# **Release Note**

Edgecore EAP102 Release v12.5.5

Document # EAP102-v12.5.5-1431-e3f388a82

Enhancement from v12.5.3-1377-1c4ece372

### 1.2 Support Microsoft 365 in Authport

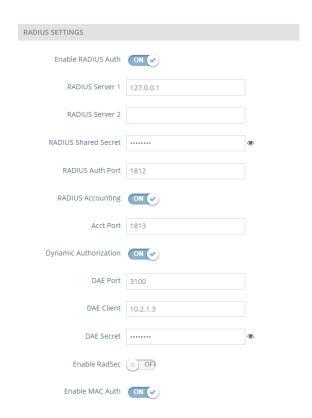
Enable Authport SSID on ecCLOUD. Microsoft 365 is supported in the captive portal, allowing clients to connect to the Internet through their Microsoft 365 accounts.
